**RE: Pendleton County Fire Station
2663 HWY US 27 N.
Falmouth, Kentucky 41040
Project No. 24056**

**FROM: Brandstetter Carroll Inc.
2360 Chauvin Drive
Lexington, Kentucky 40517
Phone 859-268-1933
Fax 859-268-3341**

END OF ADDENDUM NO. 2

MODEL NUMBER: OT-500

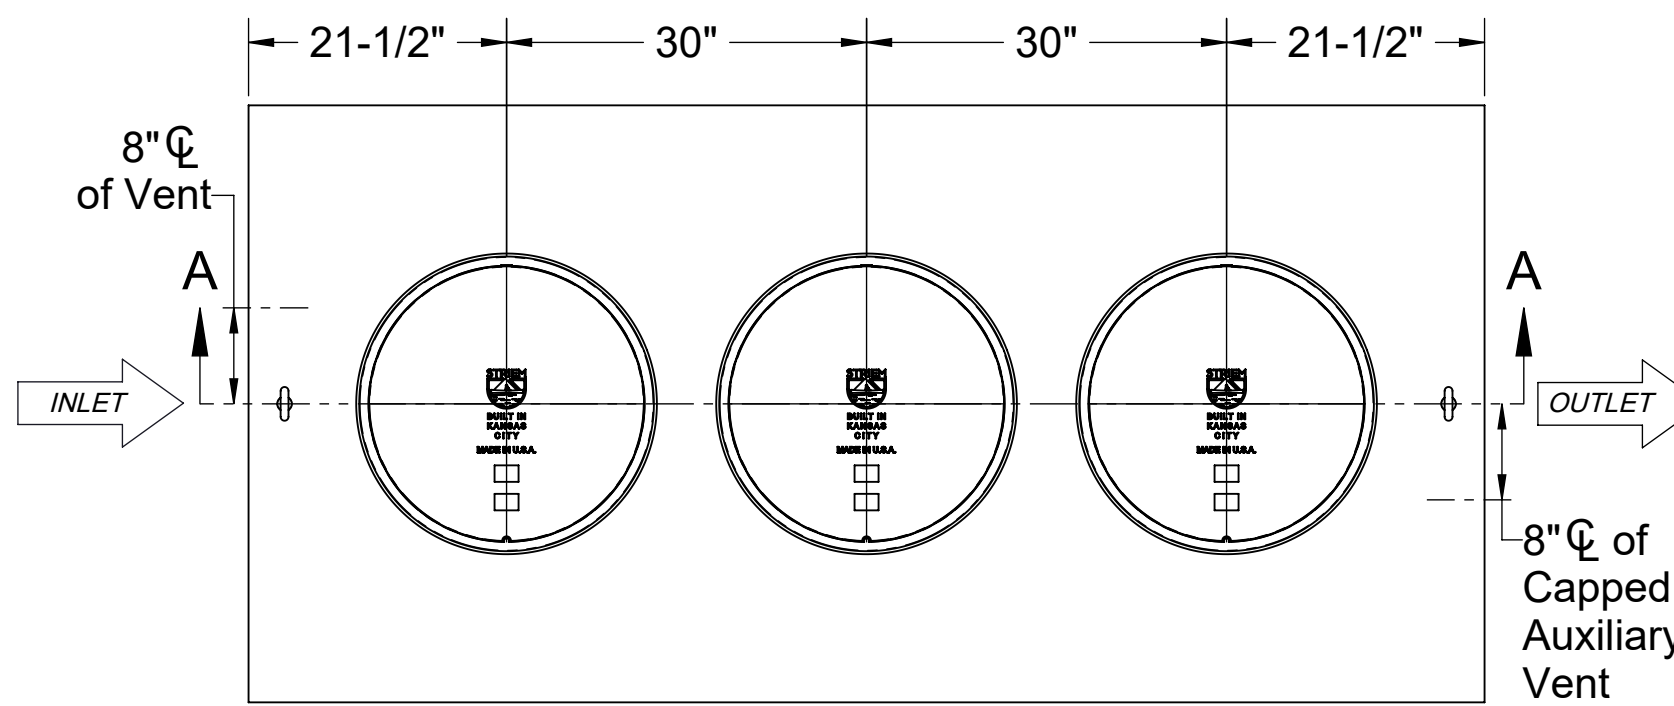
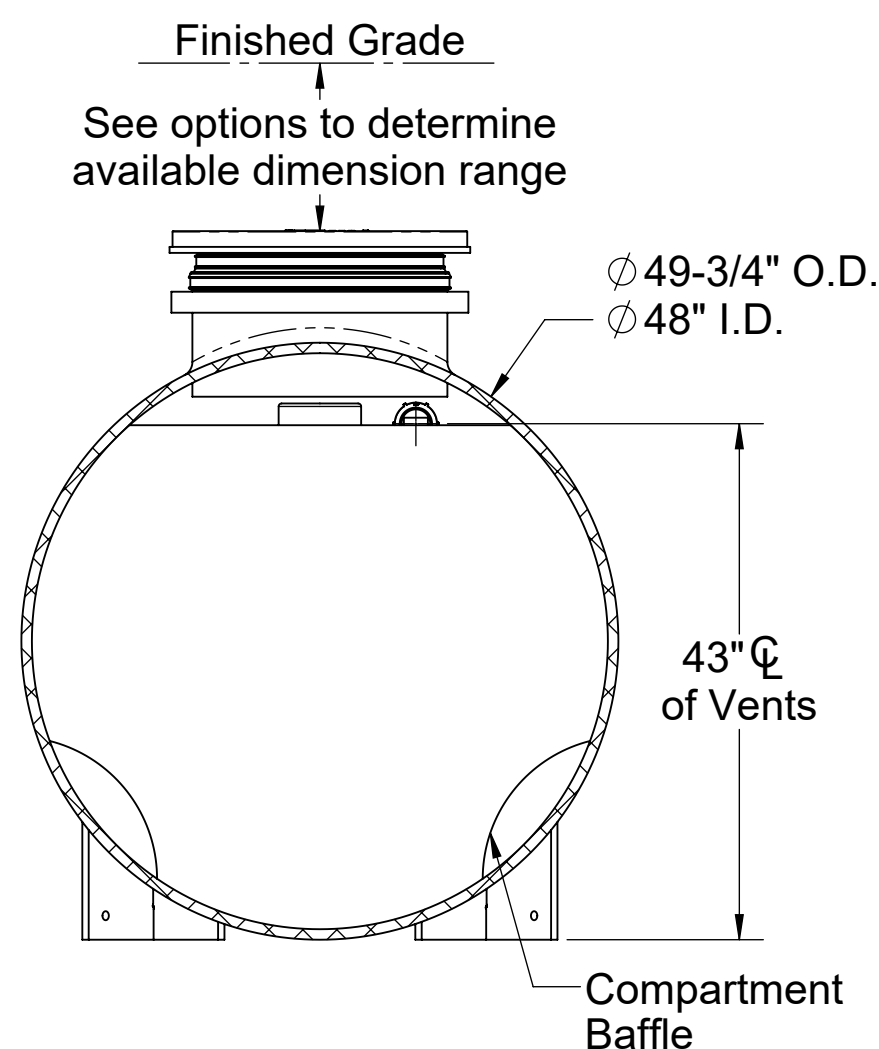
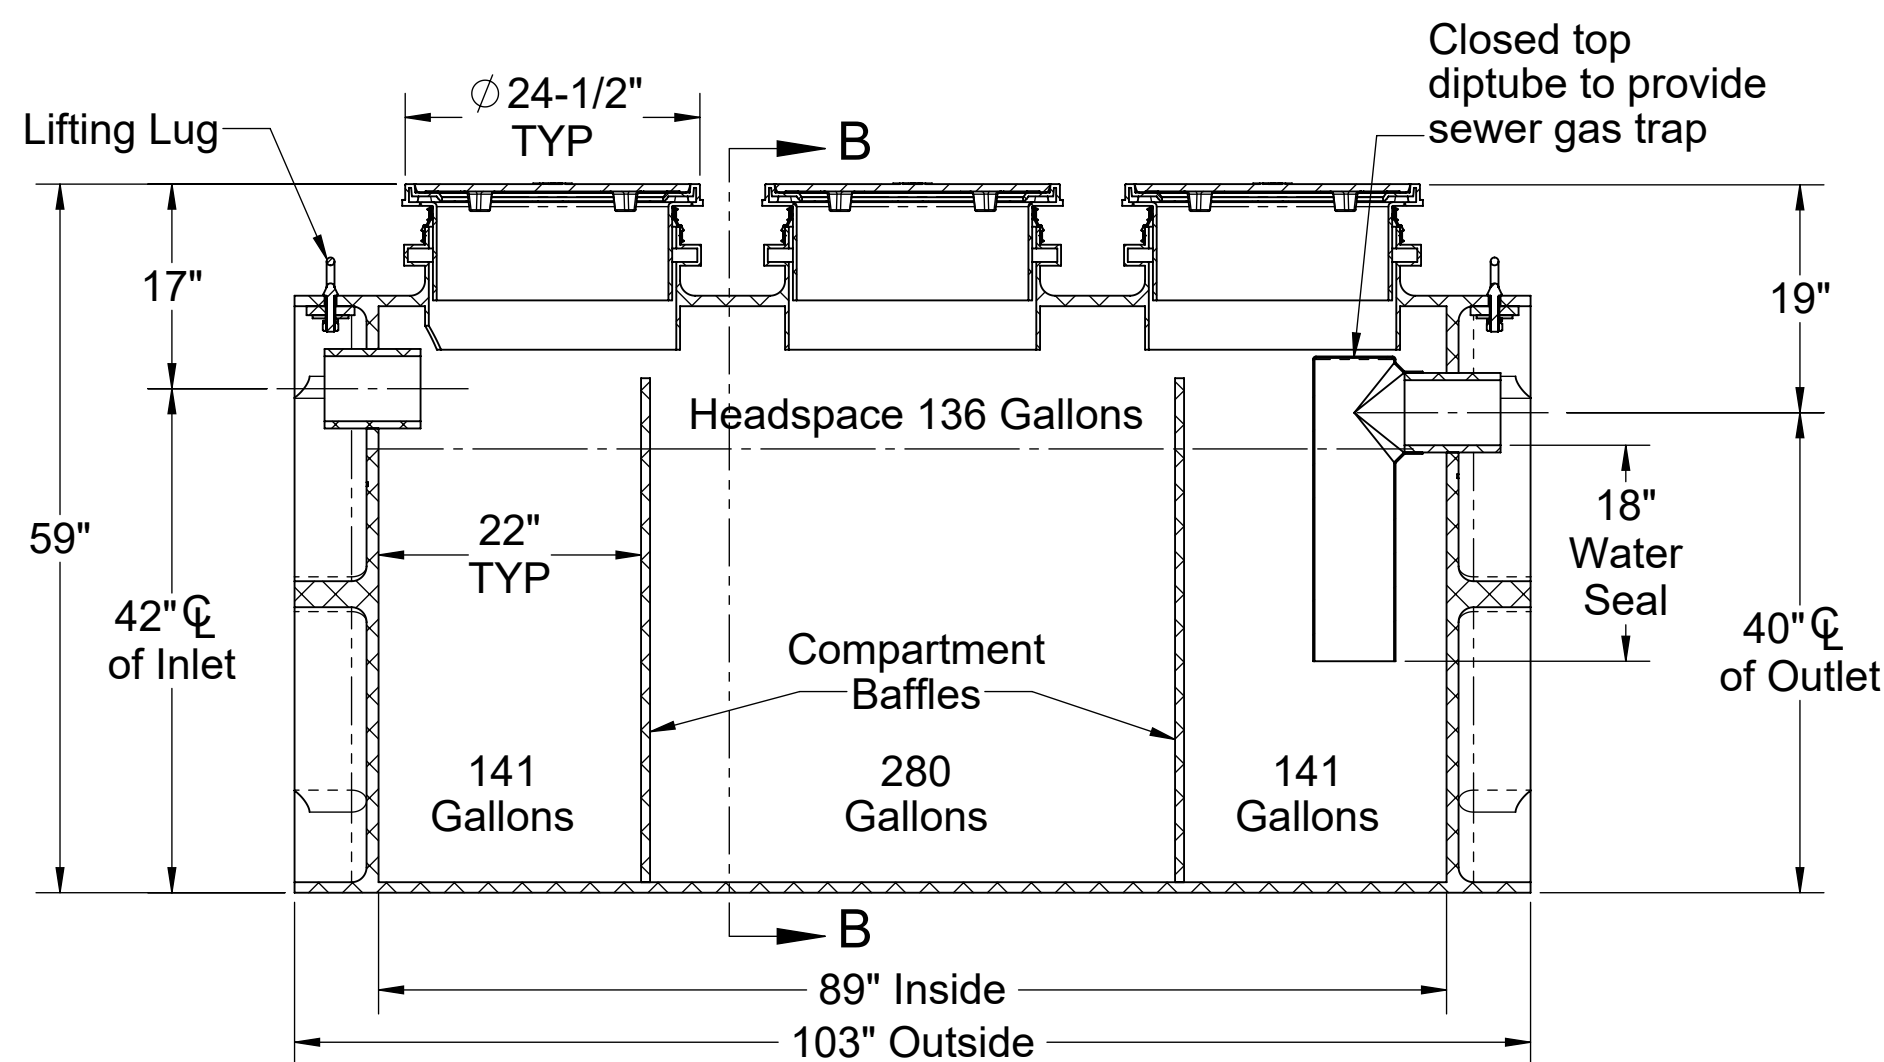
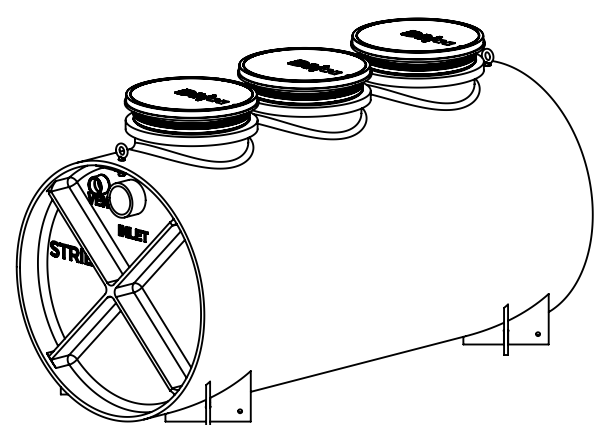
1. Are we responsible for moving the metal building to the site?
 - a. Yes.
2. Are we cleaning and painting existing steel?
 - a. Yes.
3. Can you provide information on the oil/sand separator? Drawing C-105 note #1 says to refer to the plumbing drawings for information on the oil interceptor. Drawing P101 Note

#4 say to refer to site plan.

- a. The oil/sand separator is to be Striem model number OT-500. Interceptor to be installed in accordance with all manufacturer's instructions and all local plumbing code. Refer to civil drawings for exact location and attached cut sheet.
